# Access Compliance Report

## Public Rights-of-Way

### (Curb Ramps)

Intersection ID: 51504	Main Street: DUNSLOW_CT	Cross Street: EASTFIELD_PARK_DR	Location: E
ADA ID: 6B3B45893C32	Ramp Type: PerpDiag	Initial Pass/Fail: Fail	Overall Compliance: No
Severity Score: 12.5			
Codes/Mitigation Info/Possible Solution		Field Measurements/Component Compliance

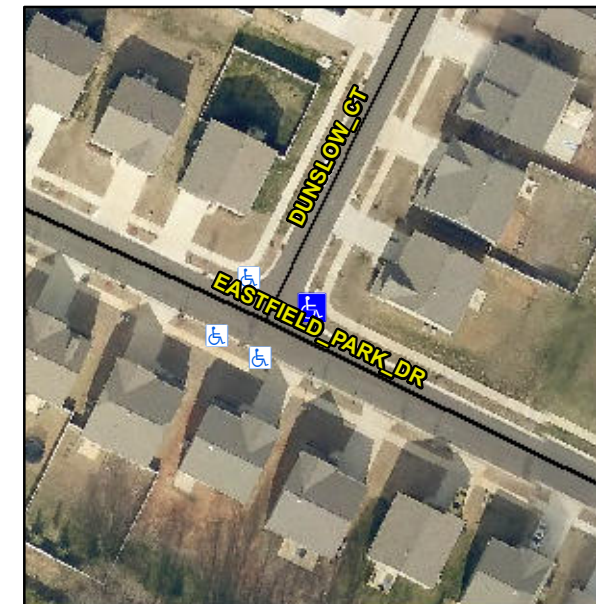
**Not Found, R304.5.3**

Compliance	Description	Data	Compliance	Description	Data
N/A	Ramp Length (in)	64.0	Yes	Ramp Slope (%)	5.1
Yes	Ramp Width (in)	48.0	No	Ramp XSlope (%)	5.6
N/A	Flare Type LT	N/A	N/A	Flare Type RT	N/A
N/A	Flare Slope LT (%)	N/A	N/A	Flare Slope RT (%)	N/A
N/A	Flare Traversable LT?	N/A	N/A	Flare Traversable RT?	N/A
N/A	Landing Length (in)	N/A	N/A	DWS Provided?	N/A
N/A	Landing Width (in)	N/A	N/A	DWS Contrast?	N/A
N/A	Landing Slope (%)	N/A	N/A	DWS Length (in)	N/A
N/A	Landing X Slope (%)	N/A	N/A	DWS Full Width?	N/A
N/A	Landing Curb? (Y/N)	N/A	N/A	DWS Offset (in)	N/A
N/A	Shared Landing?	N/A			
N/A	Gutter Ponding?	N/A	N/A	Gutter Slope (%)	N/A
N/A	Gutter Lip Ht (in)	N/A	N/A	Gutter X Slope (%)	N/A
N/A	Painted X Walk1?	No	N/A	Painted X Walk2?	No
	X Walk 1 Direction	To NW		X Walk 2 Direction	To SW
N/A	X Walk 1 Width (in)	N/A	N/A	X Walk 2 Width (in)	N/A
	X Walk 1 Slope (%)	1.1		X Walk 2 Slope (%)	4.9
	X Walk 1 X Slope (%)	5.7		X Walk 2 X Slope (%)	2.4

**Remove & Replace Curb Ramp With Two New Directional Ramps or Equivalent.**
